ADDENDUM # 1

IFB # V-1679 – Bus Operator Safety Barrier

January 25, 2017

Appendix B: Revised Drawings for 1800 Series Buses

NICE ORION VII DRIVER BARRIER	
DWG. NO.	NICE-ORION-VII	ELEC. FILE NO.	
DATE	12/21/16	SCALE	1:10
DESIGNED AND ENGINEERED BY		SHT.	1 OF 1
DATE	12/21/16	REV.	A
APPROVED BY		DATE	12/21/16

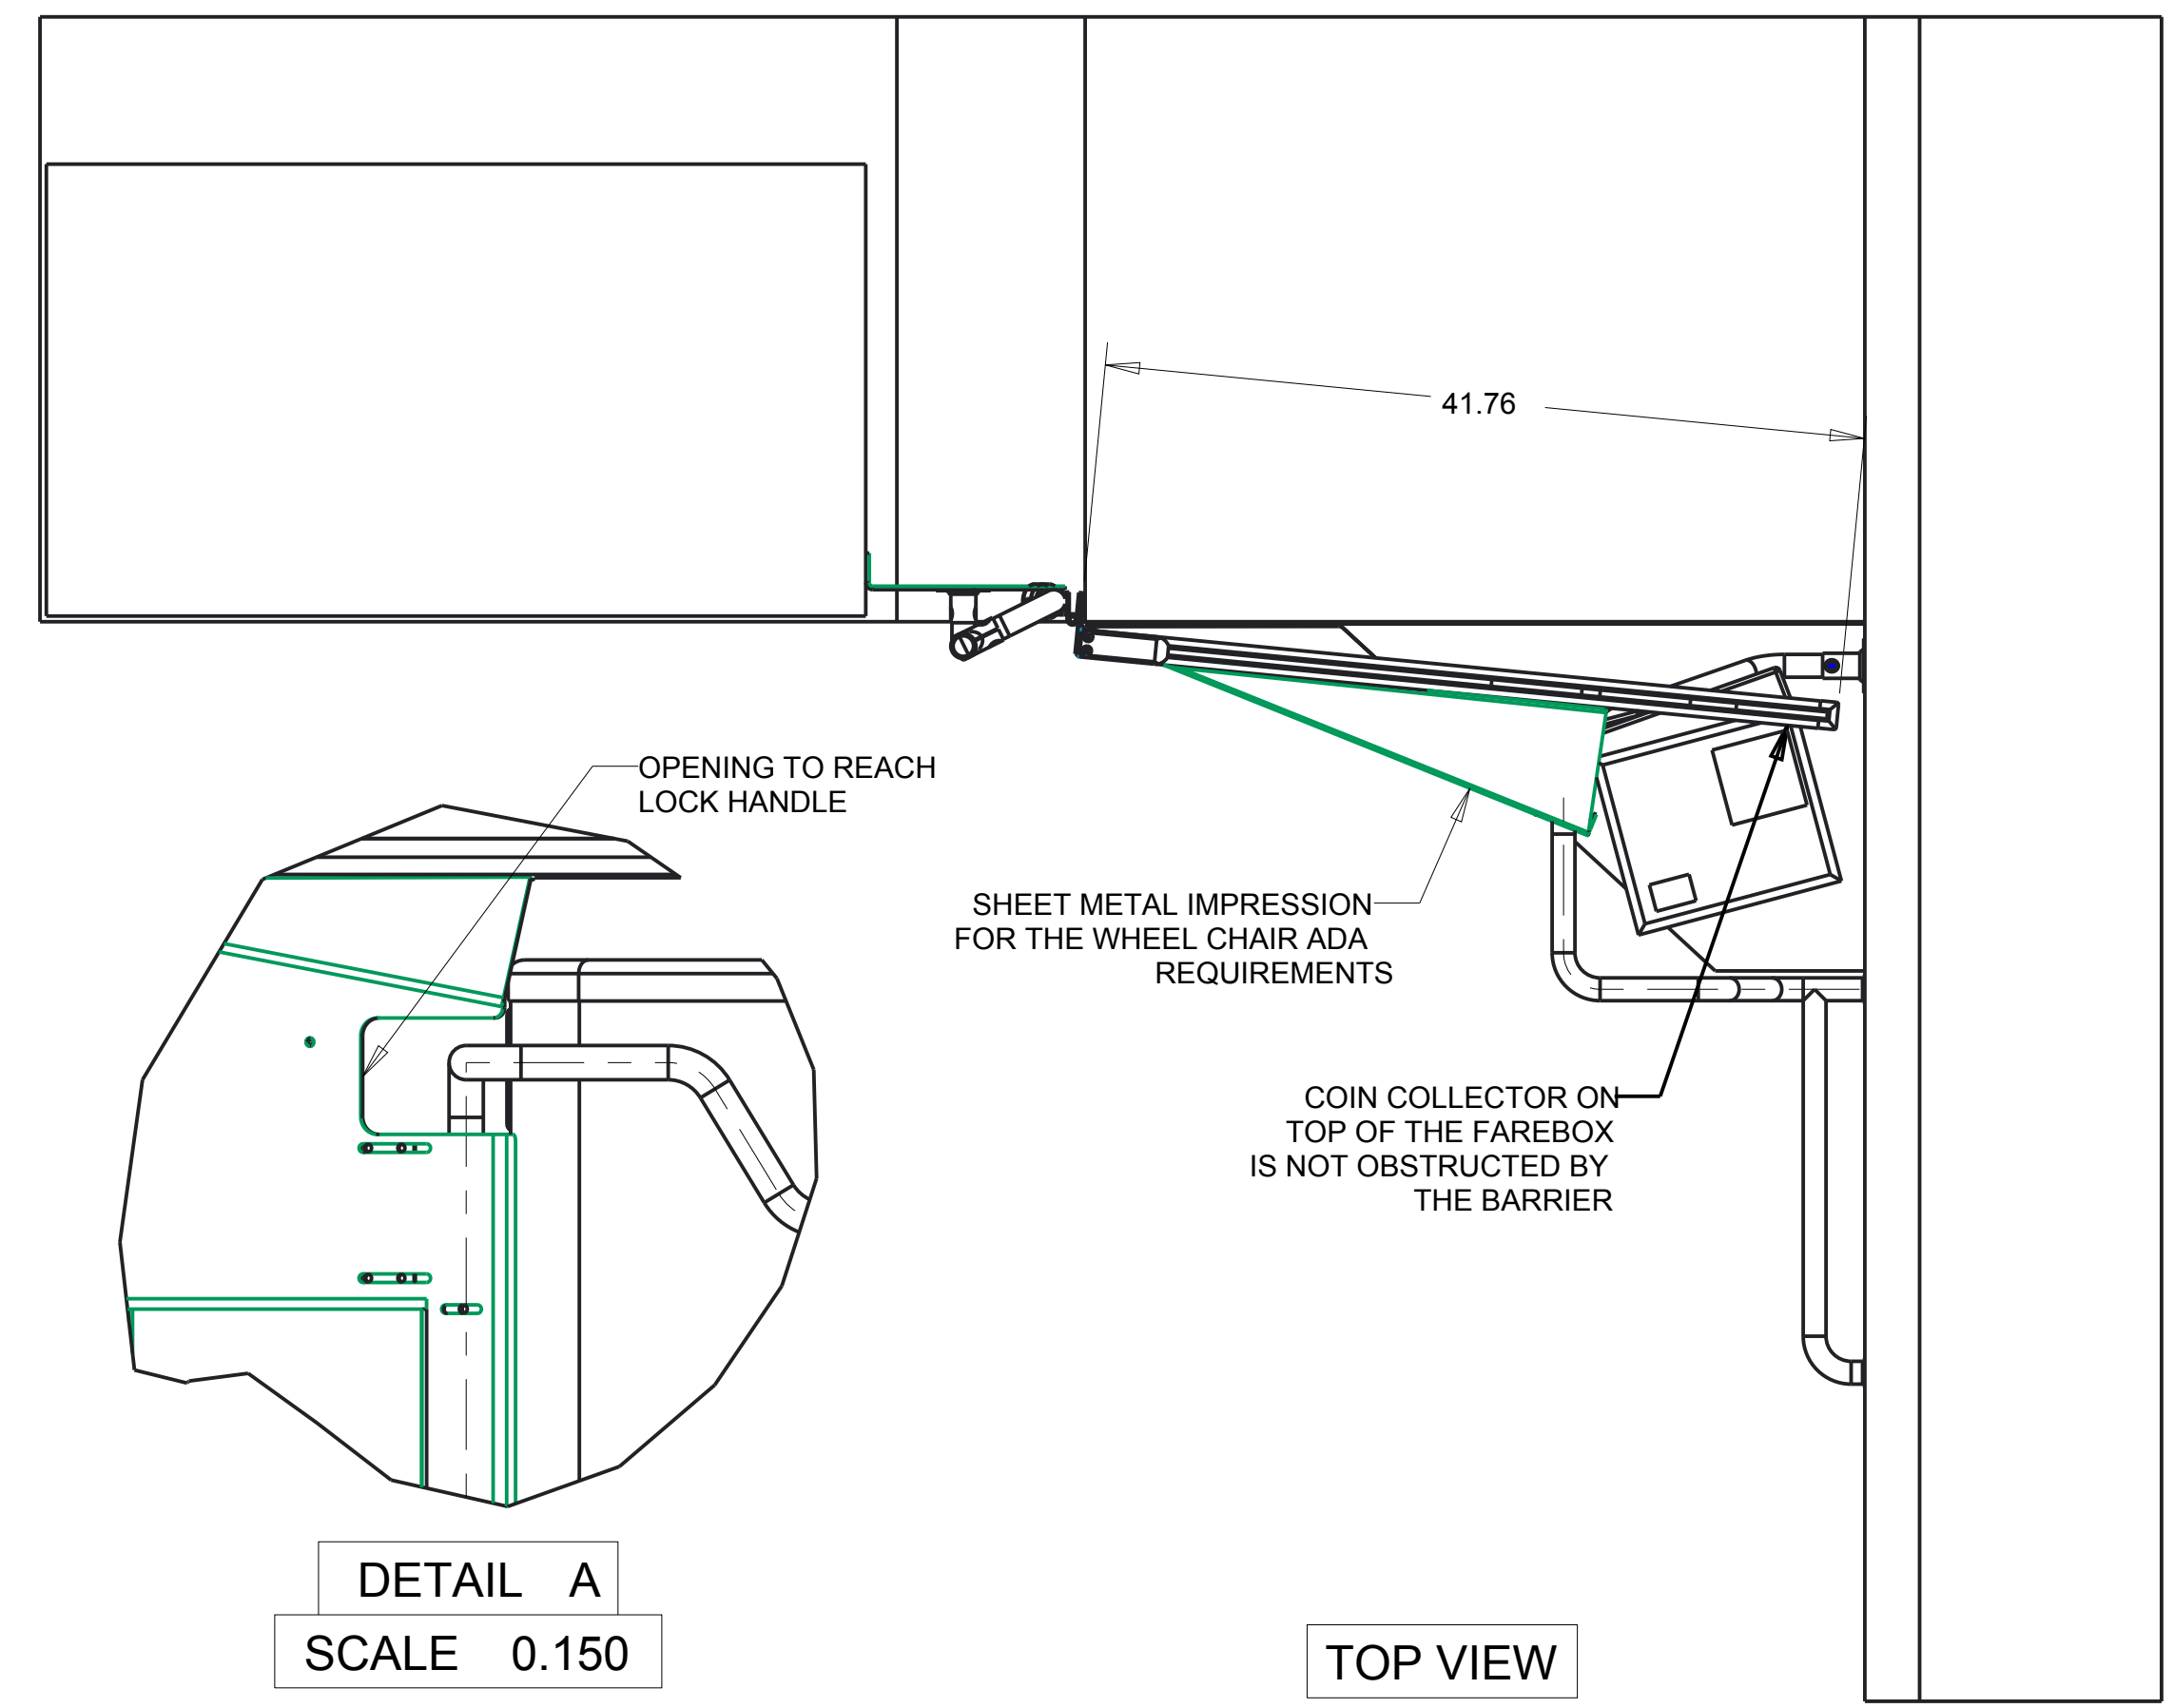
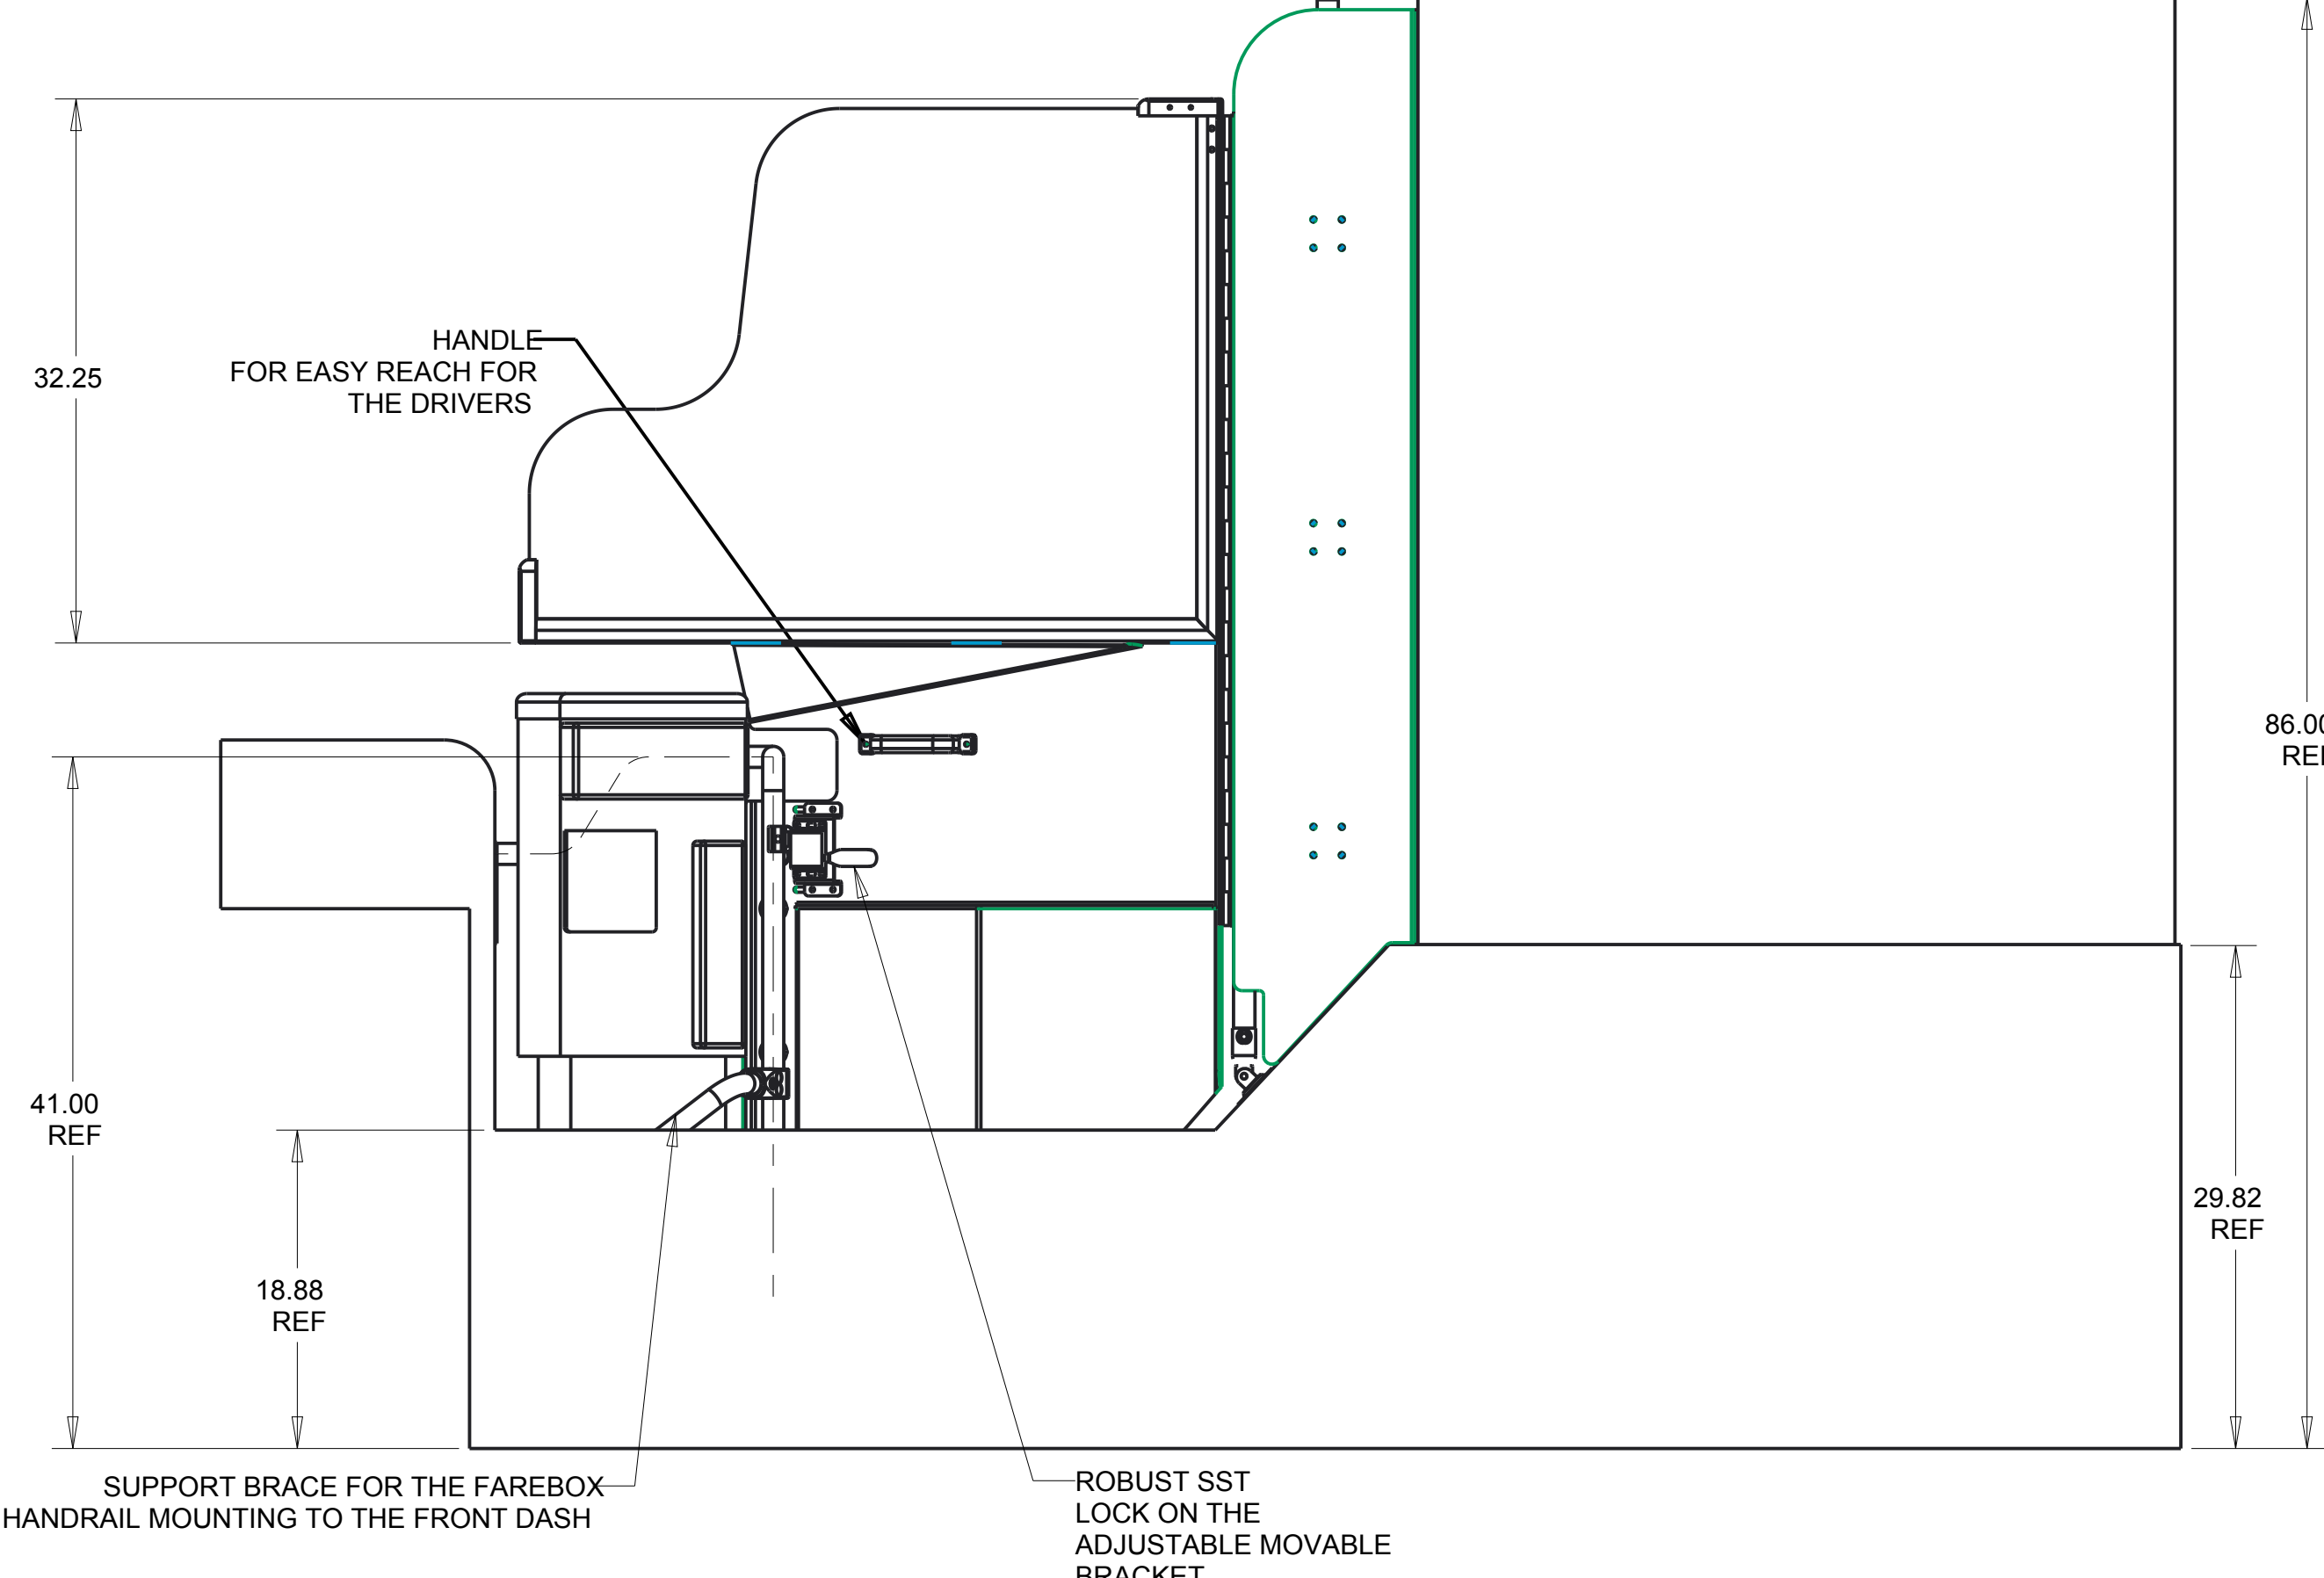
Drawings are revised to include dimensions of the Bus Operator Safety Barrier for each of the bus series. The drawings are in the following pages.

REVISIONS			
REV	DESCRIPTION	DATE	APPR
-	NOT RELEASED FOR PRODUCTION	08/21/15	NICE
A	ADDED DIMENSIONS	01/24/17	NICE

Answer: Drawings are attached to this addendum.
